GENERAL INFORMATION

Location: 7800 Picture Drive

Request: 1) Rezoning from CO-1 Commercial Office 1.0 to CO-1(PD) Commercial Office 1.0 (Planned Development);
2) Preliminary and final development plans for a major commercial golf facility; and
3) Conditional use permit for a major commercial golf facility.

Graphic 1: Proposed Rezoning to apply PD Overlay at 7800 Picture Dr.

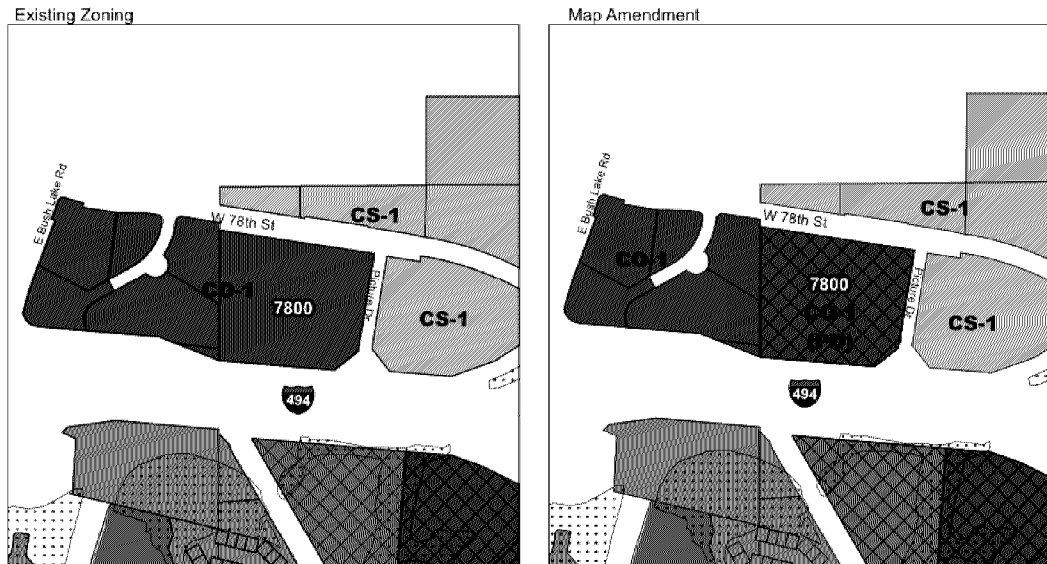
Staff believes the proposed rezoning to apply the planned development overlay, as depicted in Graphic 1 below, is consistent with the Comprehensive Plan and provides a public benefit through the introduction of standards flexibility for the unique needs of recreation/entertainment uses. In the following performance standards section, staff identifies the requested flexibility for the project. Staff recognizes the public benefit for most, but not all of the requested Planned Development deviations as they accommodate a complete redevelopment with a unique land use.
